INITIAL FIRE SAFETY INSPECTION REPORT

Square Apparels Limited (Extension)

RSC ID: 25620

Date: 25 April-2024

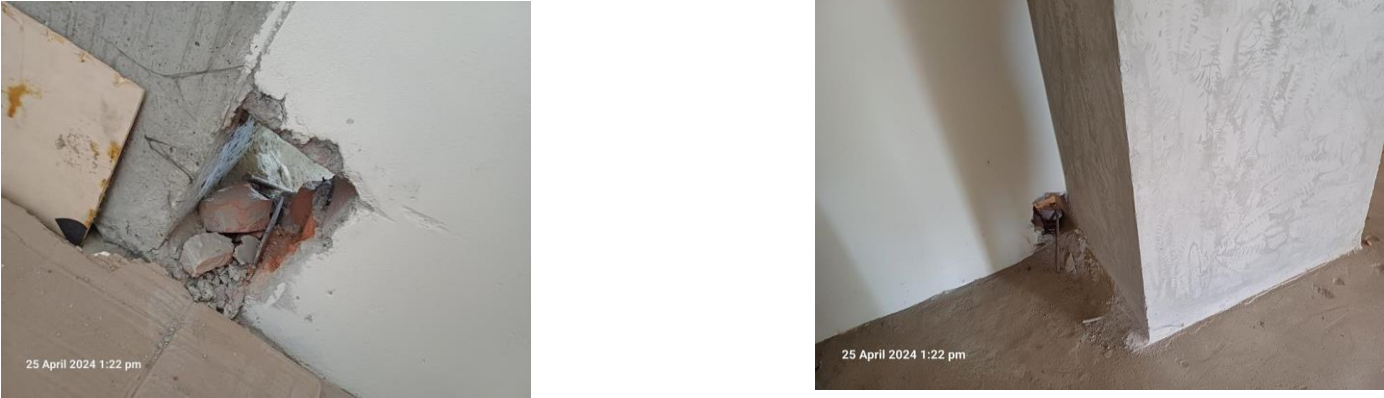
F-3	Fire rated construction	<p>Unsealed penetrations and openings are located in the fire-rated floor/ceiling assemblies.</p> <p>Location: warehouse building-expansion joint-middle area, toilet area and admin building-near stair-1, all floor.</p>	<p>Seal all penetrations and openings in floor/ceiling assemblies to maintain the fire separation at least by 3-hr. The used sealer shall be 3rd party certified and installation shall be as per manufacturer's guideline. (Type-1 Construction).</p>	Within 3 month
-----	-------------------------	--	--	----------------

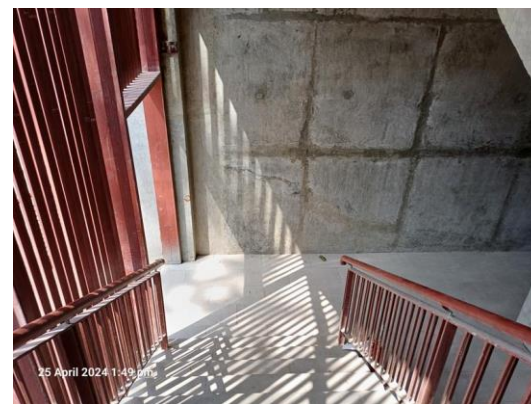
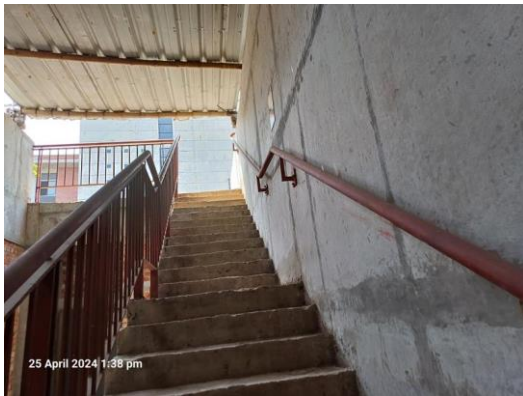
F-8	Mean of Egress	<p>Stair width was found less than 1.5m (60 inches) (Stair-01 & 02-51 inch and stair-02-34 inch for top floor.</p> <p>Location: Admin building</p>	<p>Stairs shall have a minimum clear width of 1.5 m (60 in.) for all industrial occupancies.</p>	<p>Within 3 months</p>
-----	----------------	--	--	------------------------

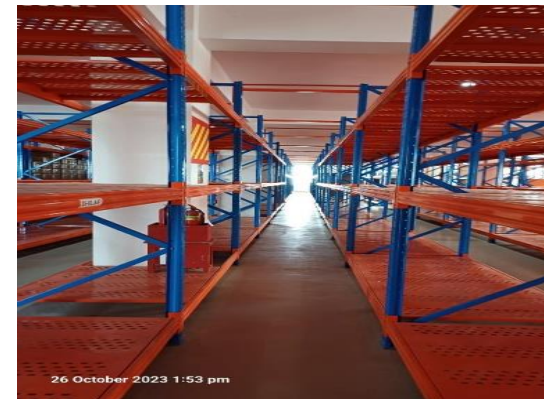
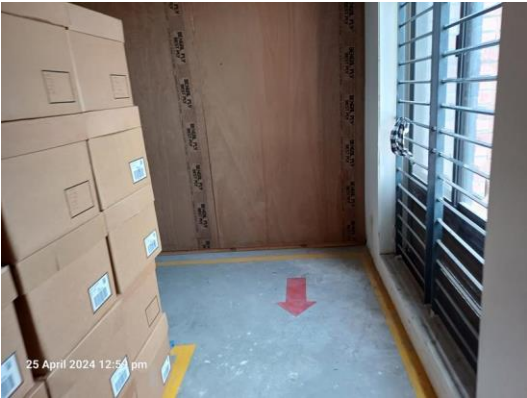
F-11	Egress Lighting	<p>Illuminated directional signs are not provided where direction of the path of travel to an exit has changed. Location: both building for several floor</p>	<p>Illuminated directional signs shall be provided where there is a change in the direction for the path of travel and the direction to an exit is not obvious.</p>	Within 1 month
------	-----------------	--	---	----------------
